Sheet: /power/		
File: power.kicad_sch		
Title:		
Size: A4	Date:	Rev:
KiCad E.D.A. 9.0.7		Id: 5/12

Sheet: /mixer/
File: mixer.kicad_sch

Sheet: /clock/
File: clock.kicad_sch

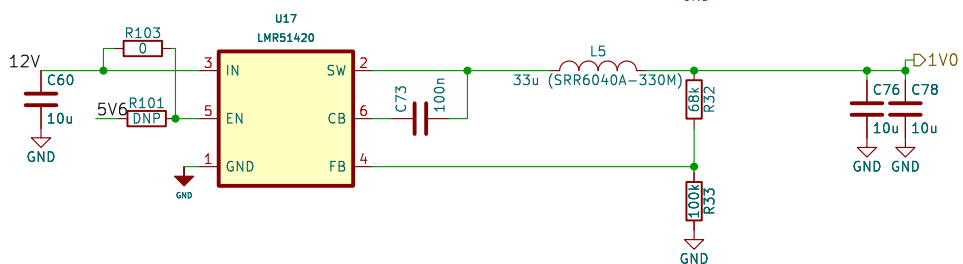
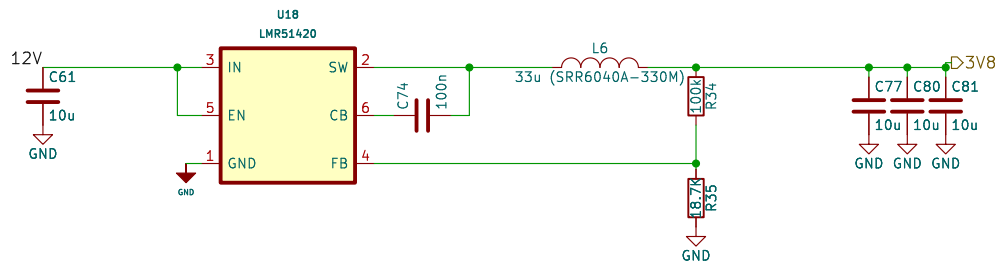
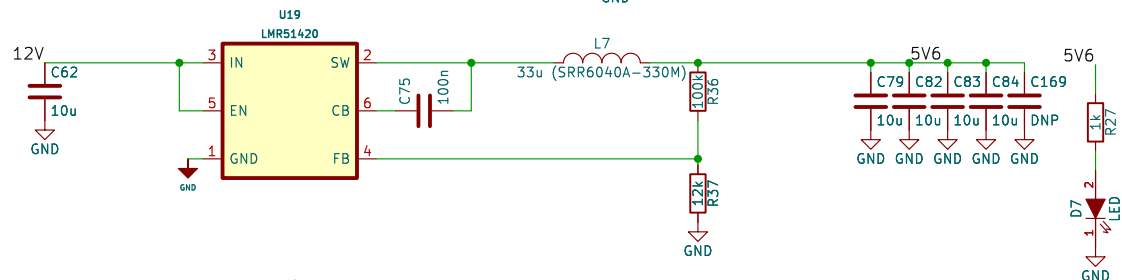
In the Artix-7 data sheet it states that the recommended power-on sequence is VCCINT, VCCBRAM, VCCAUX, and VCCO. 1v0 first 1v8 then 3v3 is the sequence so use power good

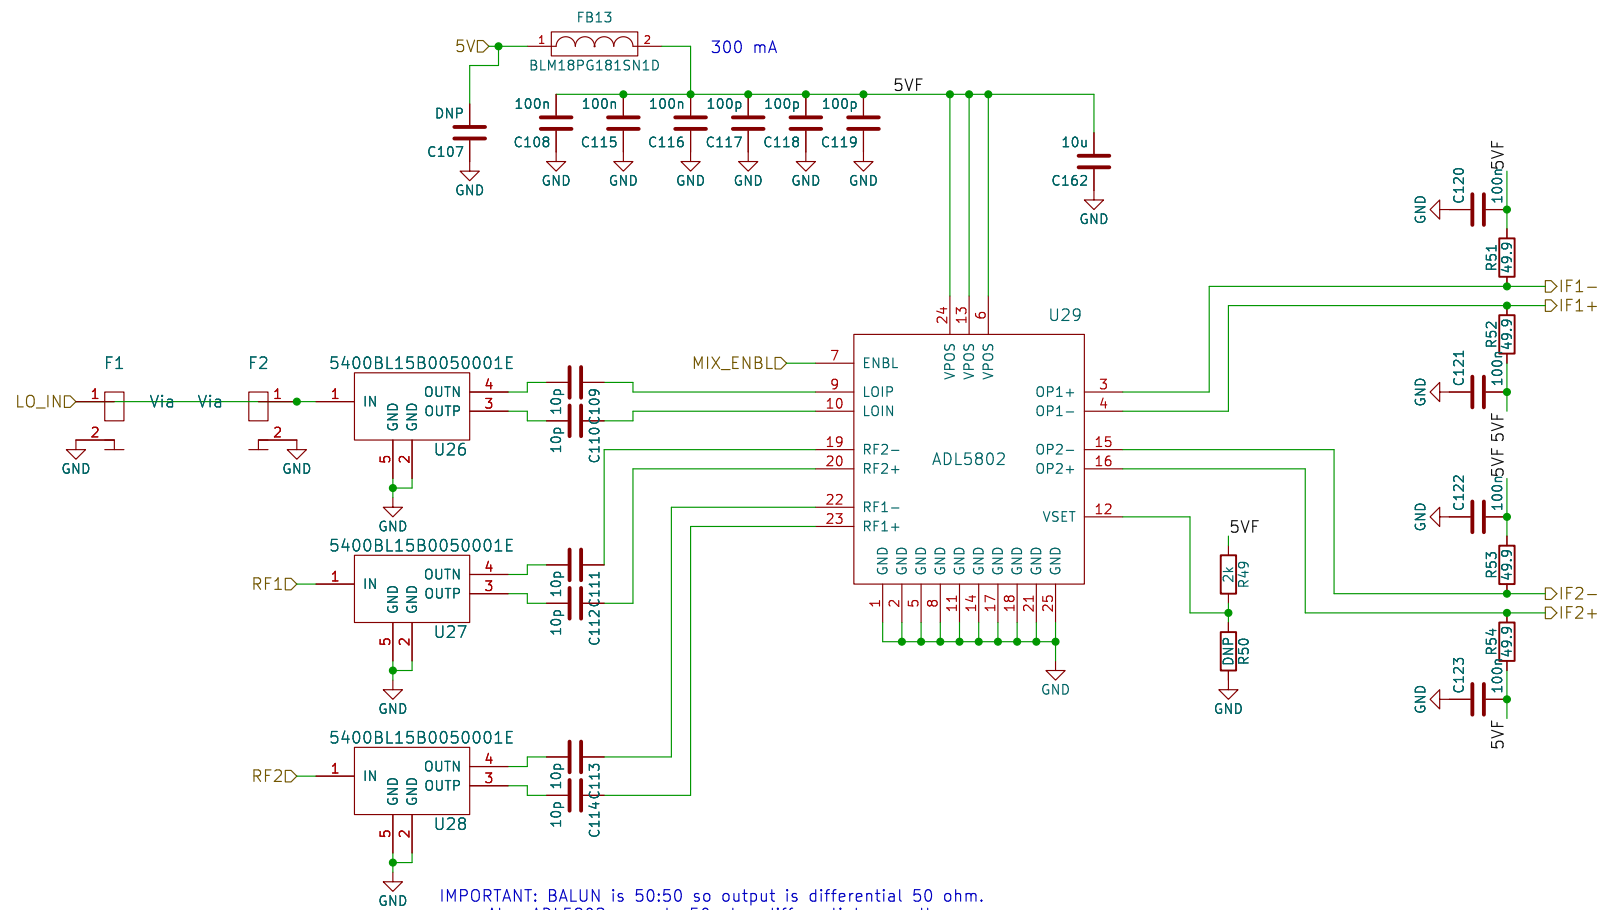
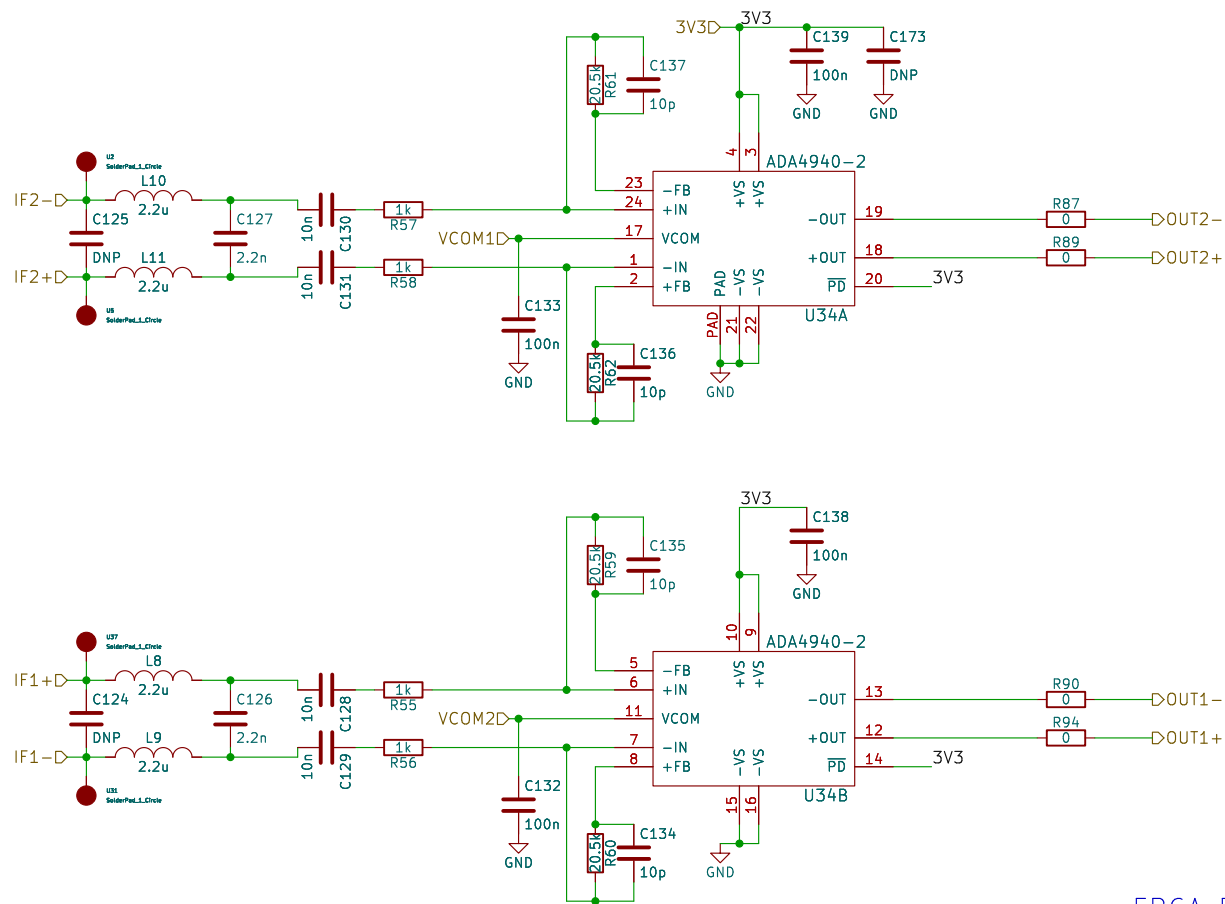
IMPORTANT: BALUN is 50:50 so output is differential 50 ohm.
Also ADL5802 expects 50 ohm differential as well.
Therefore if trace width spacing changes at that part!!!

Sheet: /if/
File: if.kicad_sch

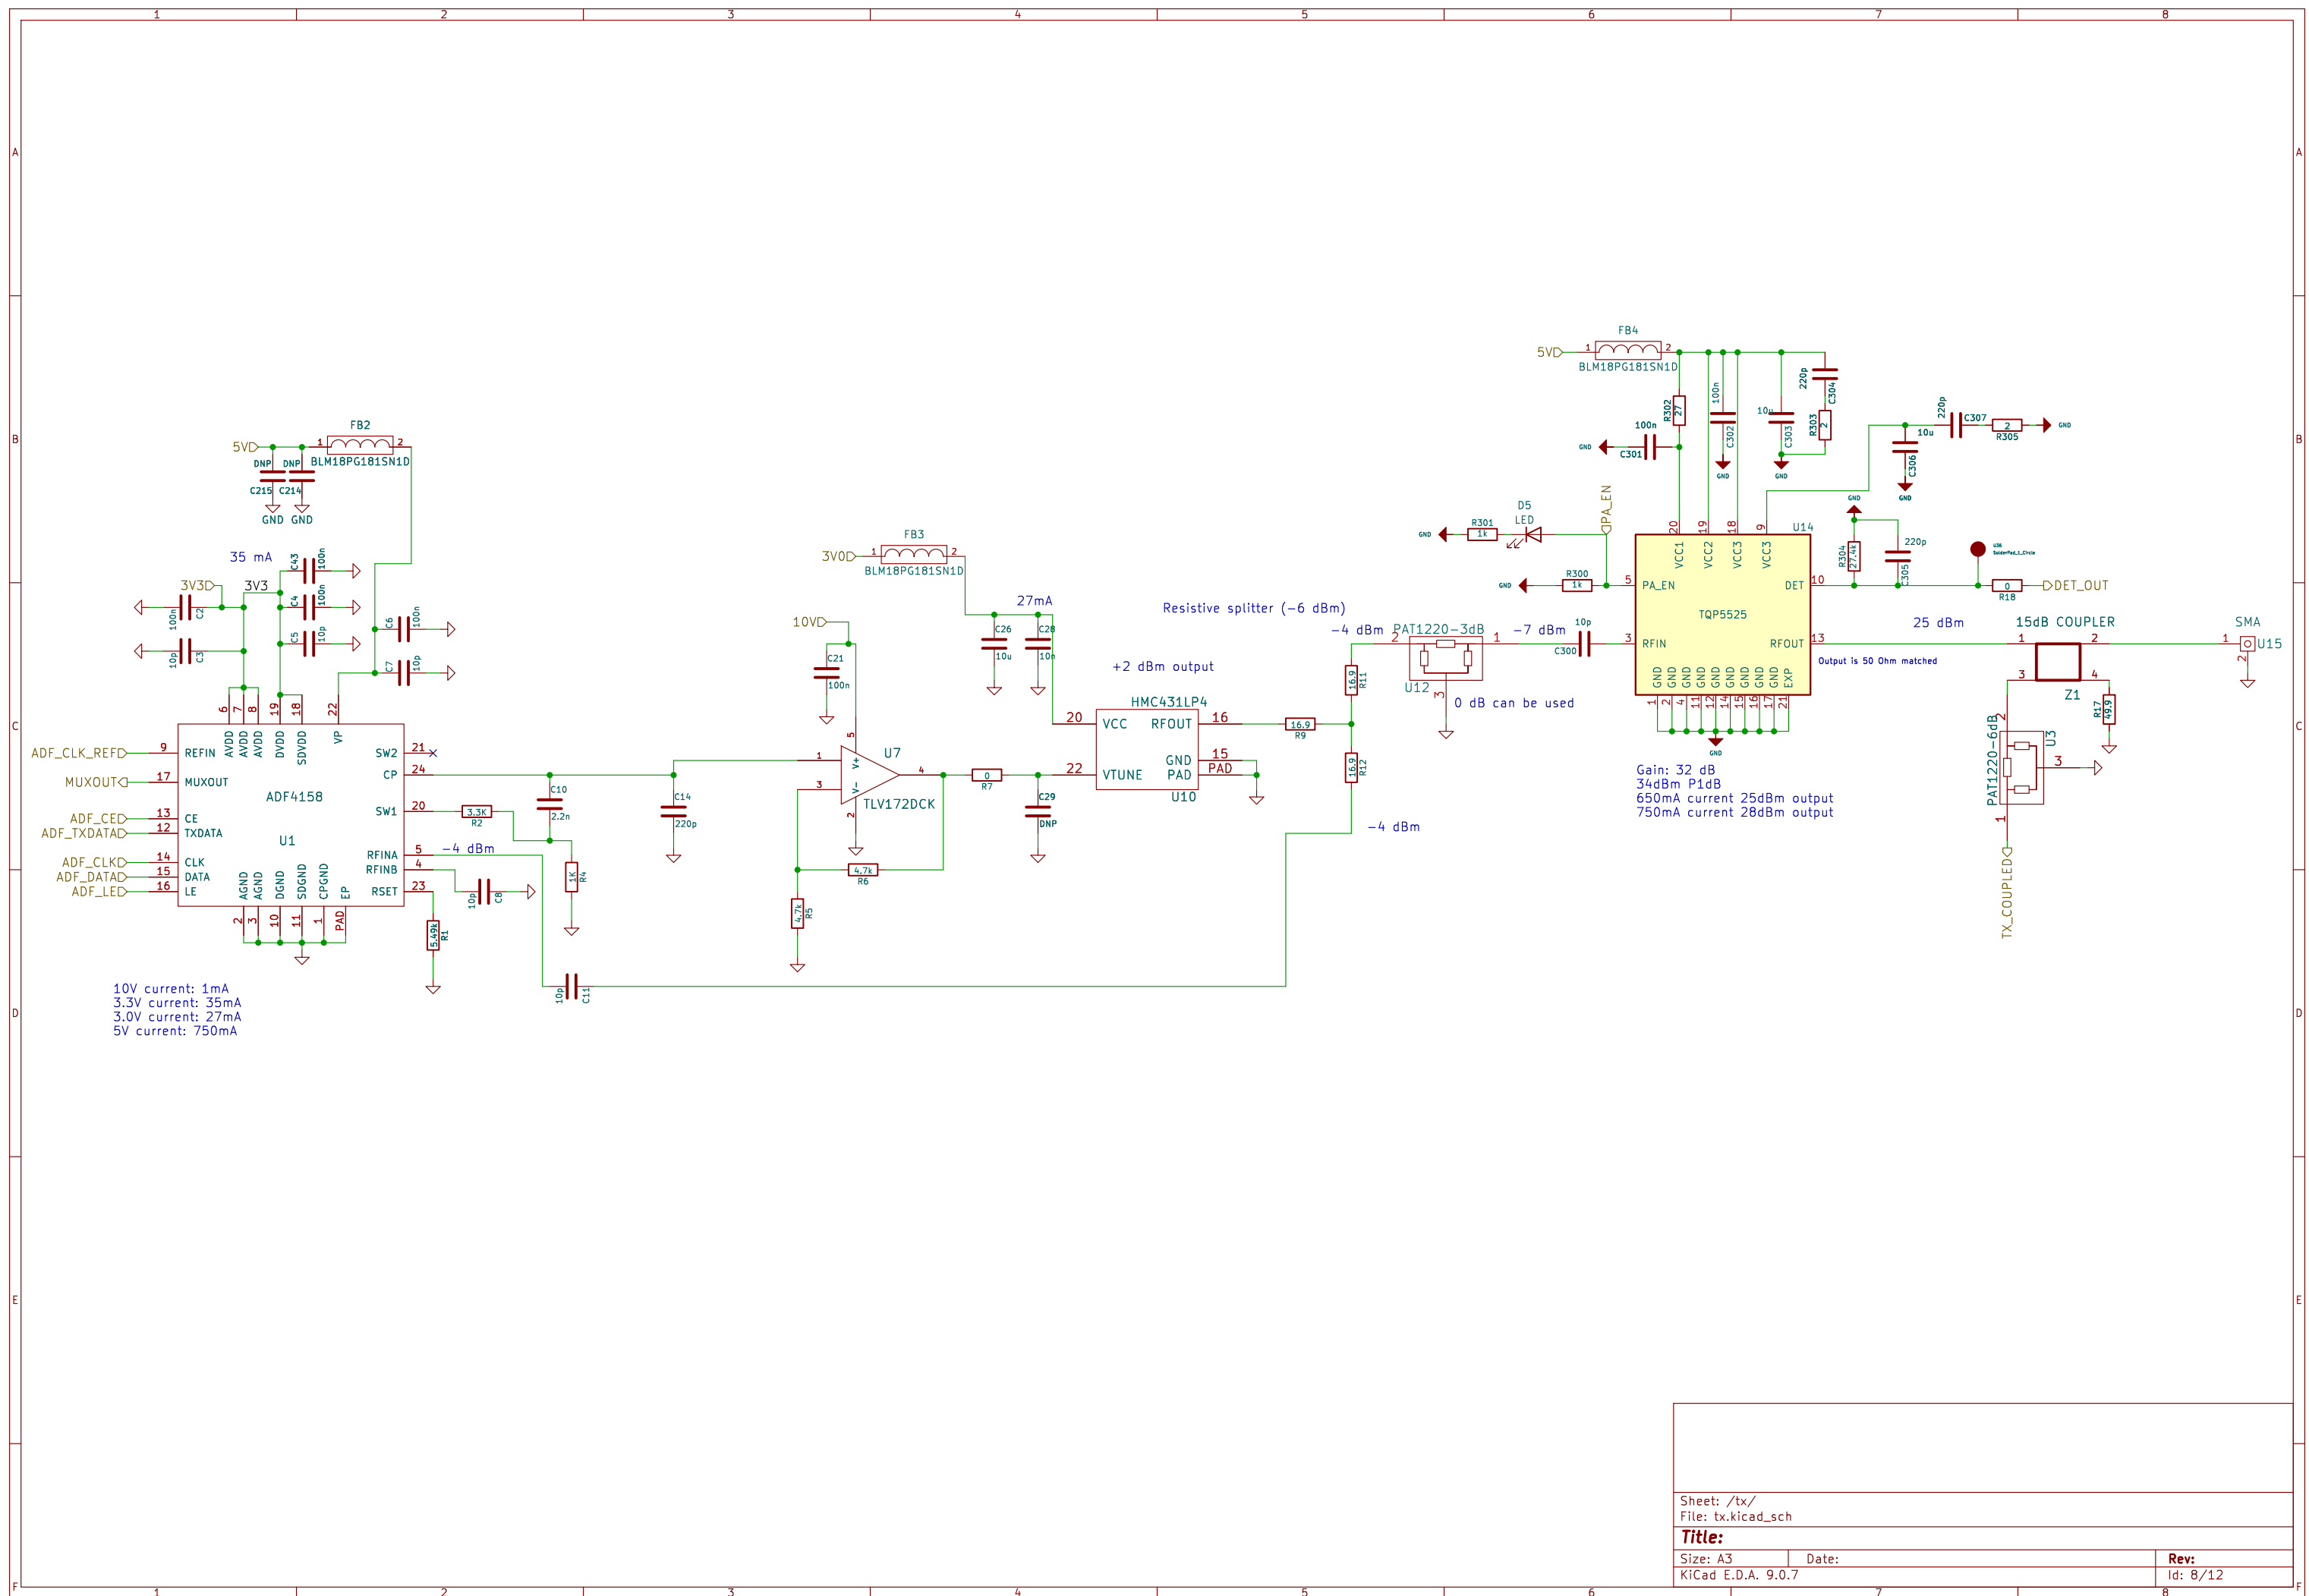
FPGA FIR Filter works perfectly.
Second stage is removed

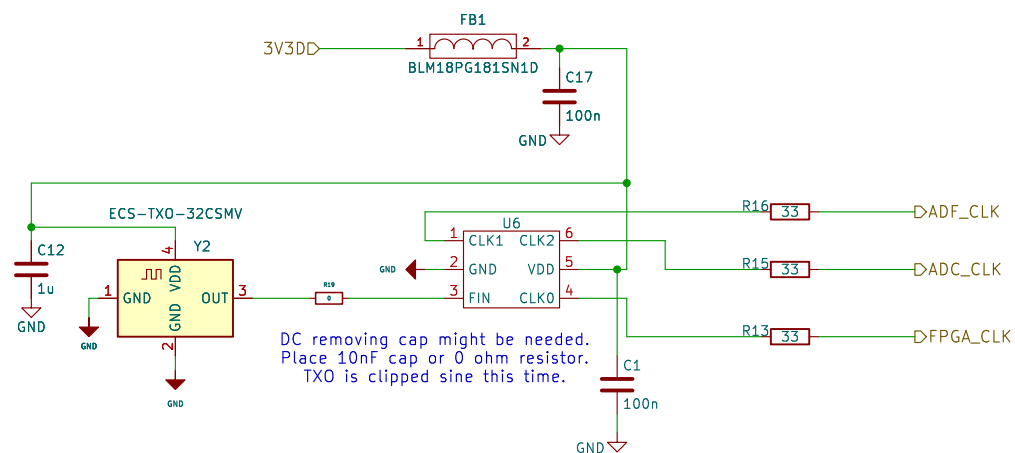
This is the prev design:
NB3N551 is obs.
Also this txo is generating pure sin.
ADC might need cmos like input not sin.
That could be the reason of duty stabilizer.

DC removing cap might be needed.
Place 10nF cap or 0 ohm resistor.
TXO is clipped sine this time.
